**CULTURAL RESOURCES OFFICE
 PRESERVATION BOARD
 REGULAR MEETING
 MONDAY - MAY 18, 2015 — 4:00 P.M.
 1520 MARKET ST. #2000
 ST. LOUIS, MO. 63103
www.stlouis-mo.gov/cultural-resources**

DATE: May 18, 2015
 ADDRESS: 5539-51 Pershing Avenue
 ITEM: Preliminary Review to construct a 5-story apartment building.
 JURISDICTION: Central West End Certified Local Historic District — Ward 28
 STAFF: Betsy Bradley, Director, Cultural Resources Office

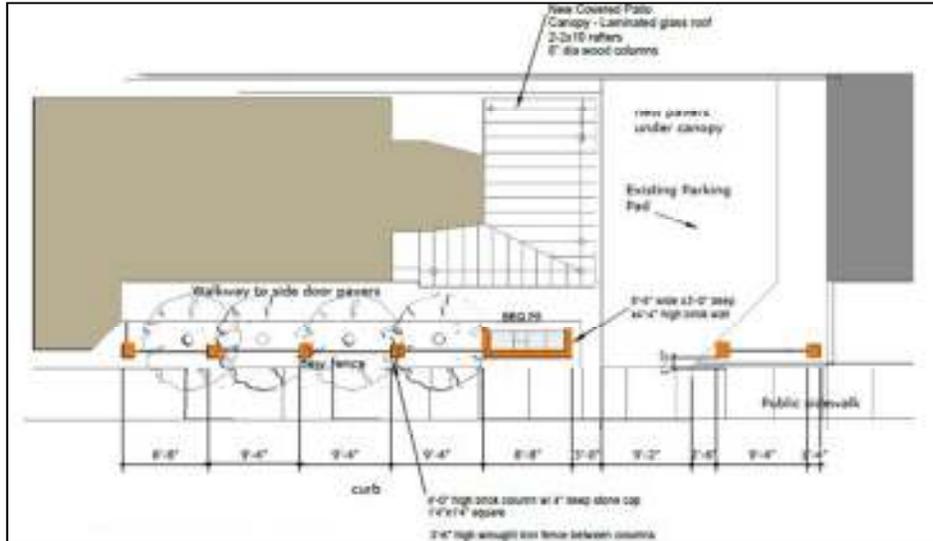
- D] Street fences shall be metal and duplicate the proportion and scale of an HME. The HME fence shall be located in front of a building of similar age and type to the property under consideration.

Does not comply. The fence does not follow an HME. Wrought-iron fences traditionally had wrought-iron posts. The brick posts were introduced to be compatible with the proposed 4-foot high brick wall to be constructed as a screen for the barbecue.

PROPOSED SITE PLAN SHOWING FENCE, SCREENING WALL AND PROPOSED PATIO COVER

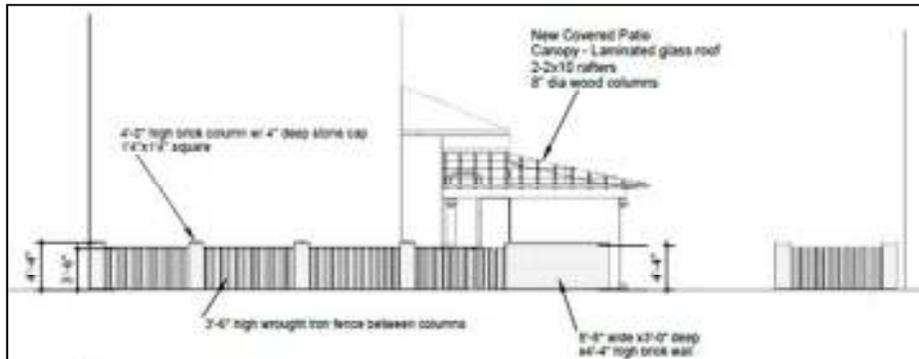
Does not comply. The permanent barbecue is a modern convenience by definition, and the yard of 1024 Mississippi is considered a public yard. However, the proposed brick screen wall will hide the barbecue from street view.

Does not comply. The proposed roof structure is not based upon a Historic Model Example. Its materials, wood and glass, and its design, are not typical of porch structures in the district and its scale is far greater than any historic porch. While there are instances of small glazed porches in other city historic districts, they appear on later houses and generally sheltering an entry. They are consistently of wrought-iron and not of the scale of this proposal.

Complies in part; the wrought-iron fence will be at a height of 42 inches; the brick posts 6 inches taller.

**EAST (LASALLE AVENUE) AND SOUTH ELEVATIONS OF PATIO COVER
NOTE THAT ROOF WILL COVER WINDOW HEADS**

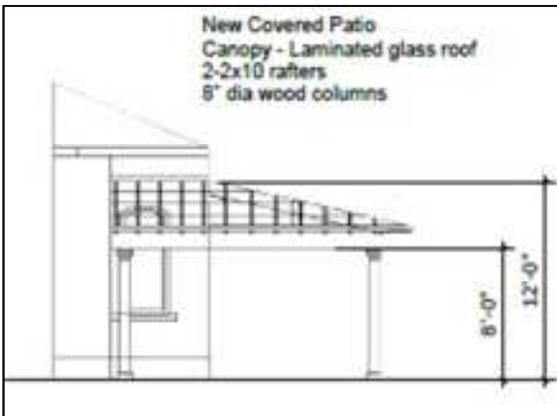
- The proposed patio cover does not follow an HME as the standards require. It is far from being consistent in design, materials or scale with historic appendages in the district.

- Staff proposed that a pergola-inspired patio cover would be more in keeping with the intent of the standards and considerably reduce the scale of the appendage.

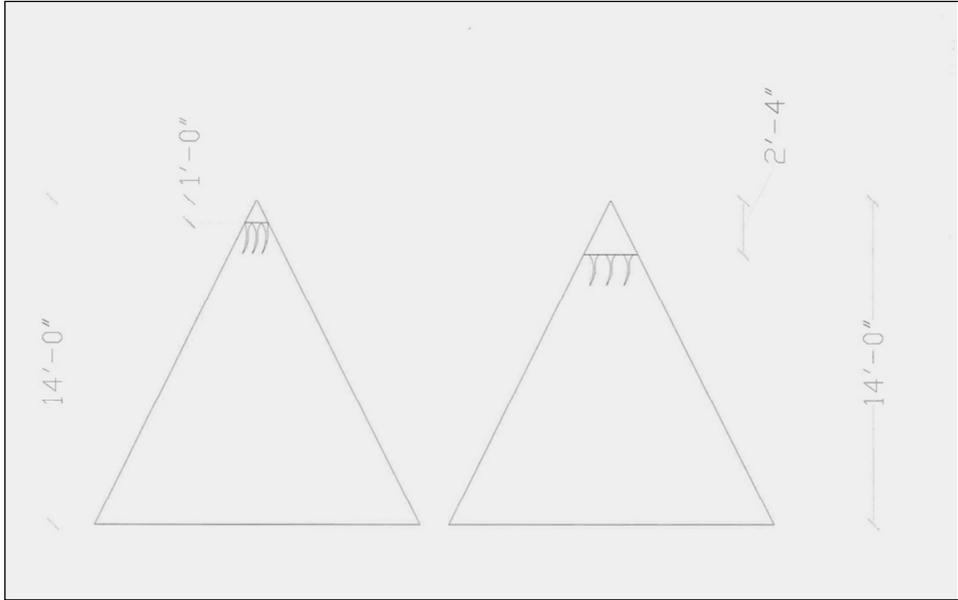
Does not comply. While it does replicate the design, the proposed turret cap would extend 1 foot 4 inches further down the turret roof. The tendrils would also extend further in proportion to the increased size. The result, a much larger cap, would significantly alter the appearance of the building.

- 3107 Shenandoah is located in the Compton Hill Local Historic District.
- The proposed turret cap replicates the original in design, but not size.
- The change in dimensions of the turret cap would noticeably alter the appearance of the building.
- The proposed cap would be much larger than similar caps in the neighborhood.
- The staff believes there are other methods of stopping the roof leakage, such as replacement of the slate beneath or installing a better barrier beneath the slate.
